19/02604/FUL Gyle Centre Spokes objection

to: Sean.Fallon@edinburgh.gov.uk
cc: Spokes PG <spokes-lothian-planning@googlegroups.com>
date: 24 Mar 2020, 13:26
subject: **19/02604/FUL Gyle Centre Spokes objection**

Spokes objects to this revised application for the Gyle Centre.

Diagram – our proposals:

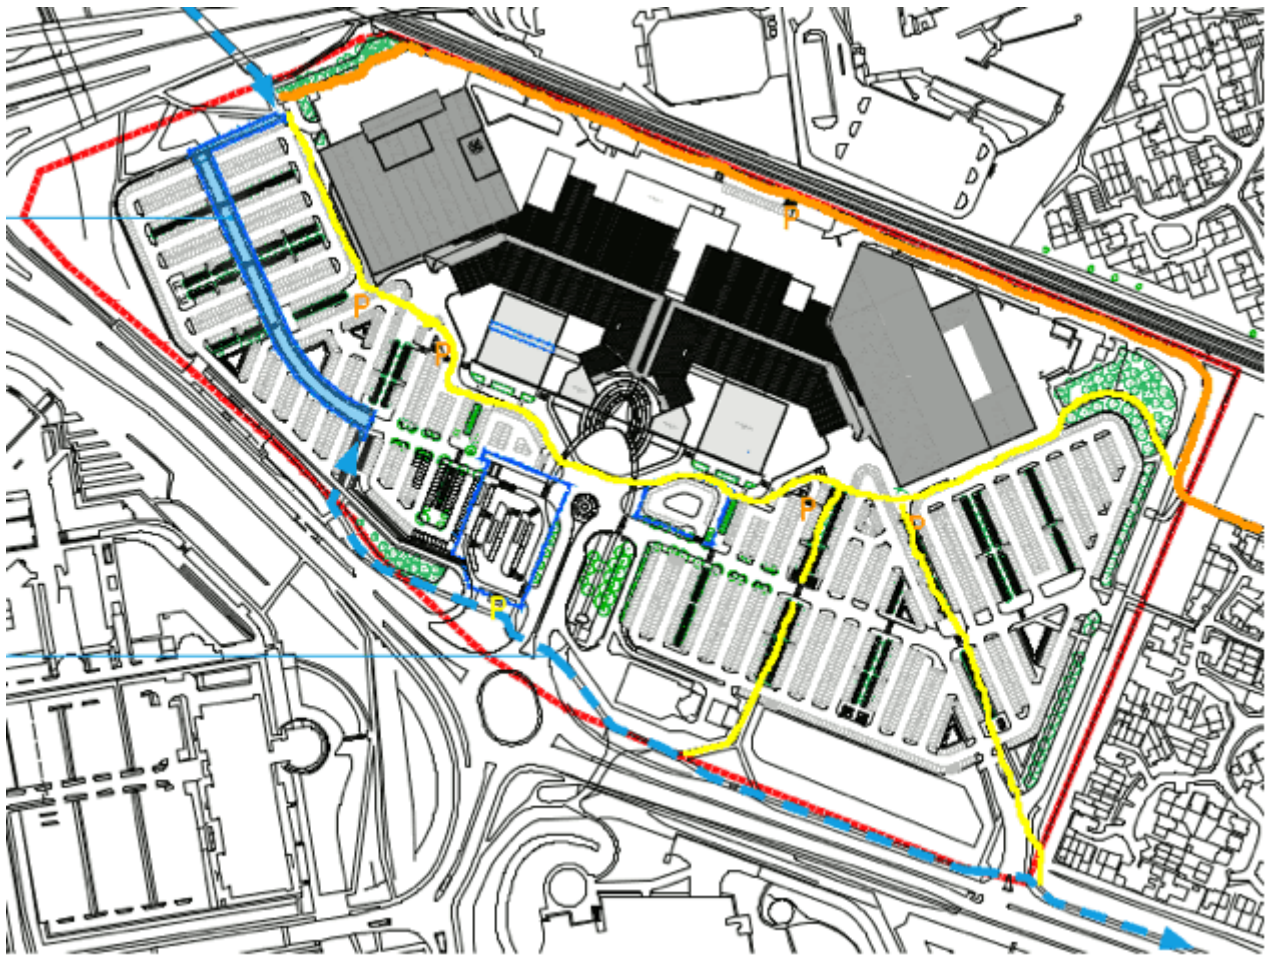
We appreciate that efforts have been made to include a cycle route to and across the site, but what is proposed is not acceptable; the cycle route is proposed on the main thoroughfare through the car park, with very many junctions into the car parking areas, meaning large numbers of turning vehicles, both in and out, and consequent danger for cyclists. It is also incomplete, since it does not take cyclists the full width of the site, i.e. to the NE corner where the “railway” path from S Gyle Station enters the periphery.

In principle, the area nearest to the buildings should be for pedestrians; next would be the cyclists; and beyond them, vehicular traffic; thus, vehicle crossings of the cycle routes and pedestrian routes should be kept to an absolute minimum, and where possible cyclists should be kept separate from pedestrians. A diagram of how this might be achieved is illustrated below.

The orange line is for commuters who want to go from one side of the Centre to the other without stopping at the Centre - for example, going between homes in western Edinburgh (Broomhall, south Corstorphine) and RBS Gogarburn, Ingliston or the Airport.

The yellow line is our route for cyclists wishing to go to the Centre. It runs close to the proposed cycle racks (marked P in orange) and away from the busy entrance road and approaches to the filling station.

Our route will mean taking away a few car parking spaces, but a dozen or so out of 2,300 is not a large number. (Some are disabled parking spaces, which would have to be moved a bit further from the entrance).

The thick light blue line is the developers' proposed route for cyclists.
